AIRCRAFT ENGINES

# SERVICE INSTRUCTION

## MODIFIED ROTARY VALVE COVER FOR ROTAX® ENGINE TYPE 582 UL SI-2ST-005

Bild / Fig. 1

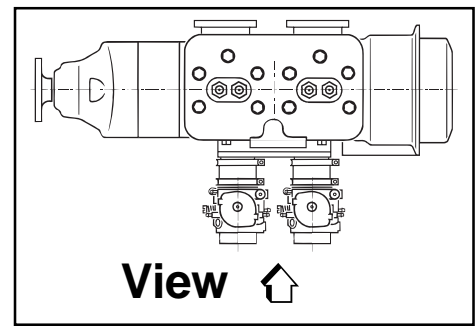
- Drill a 0.118 in dia. (drill size 32) hole (see Figure 1 item 2) through the rotary valve cover (see Figure 1 and 2 item 1).

- ◆ **NOTE:** Thoroughly clean chips and emulsion after machining operation from the rotary valve cover (see Figure 1 item 1).

Bild / Fig. 2

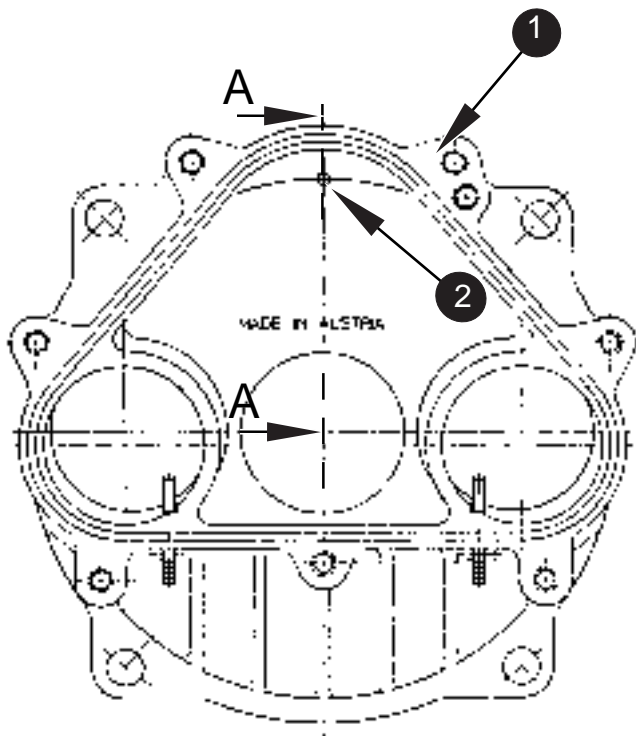
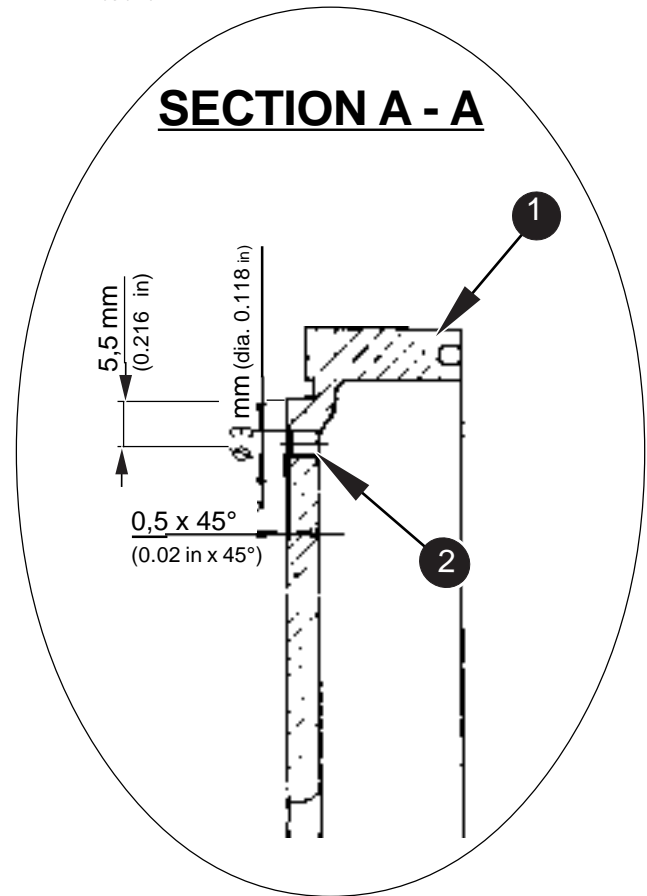
- Chamfer the bore by 0.02 in x 45° (see Figure 2 item 2) on the rotary valve side and deburr completely.
